SETTLERS VIEW

PRELIMINARY GRADING & EROSION CONTROL PLAN

SHEET: **C1**

Add: PCD File No.: SP-17-006

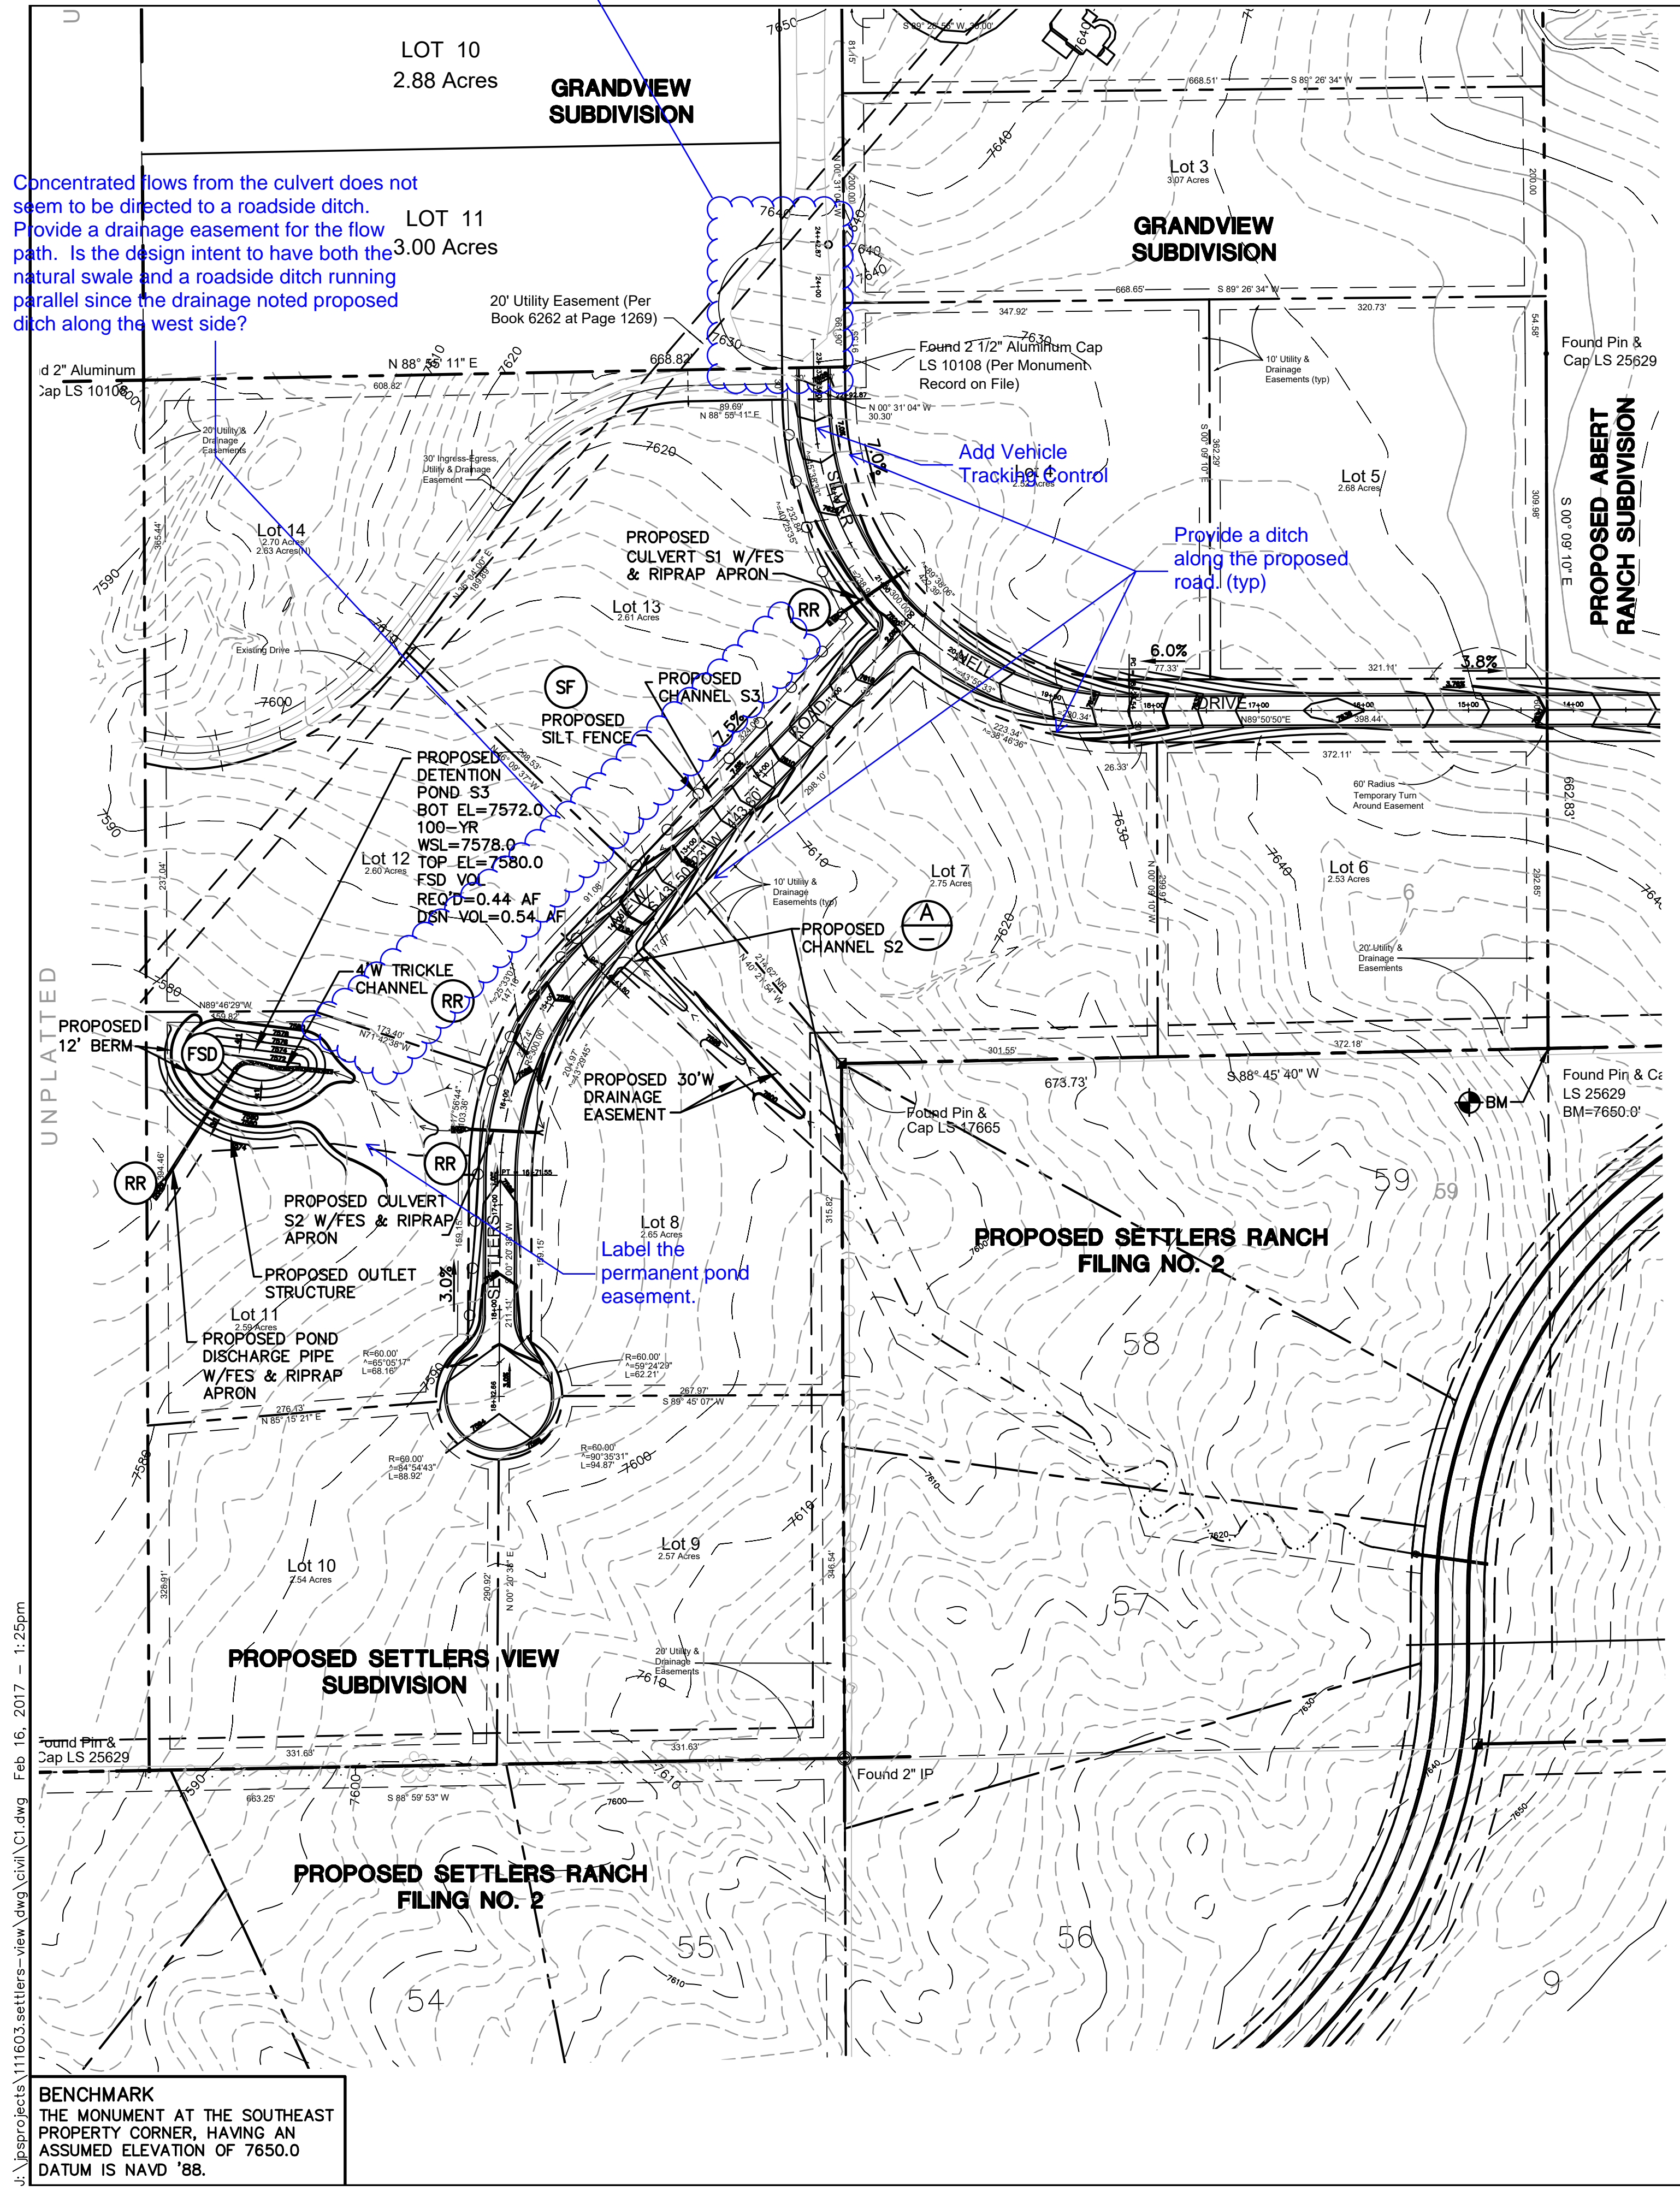
Extend improvement to include the conversion from a temp cul-de-sac to standard cross section. Coordinate with the lot owner.

Concentrated flows from the culvert does not seem to be directed to a roadside ditch. Provide a drainage easement for the flow path. Is the design intent to have both the natural swale and a roadside ditch running parallel since the drainage noted proposed ditch along the west side?

Label the permanent pond easement.

Add Vehicle Tracking Control

Provide a ditch along the proposed road. (typ)
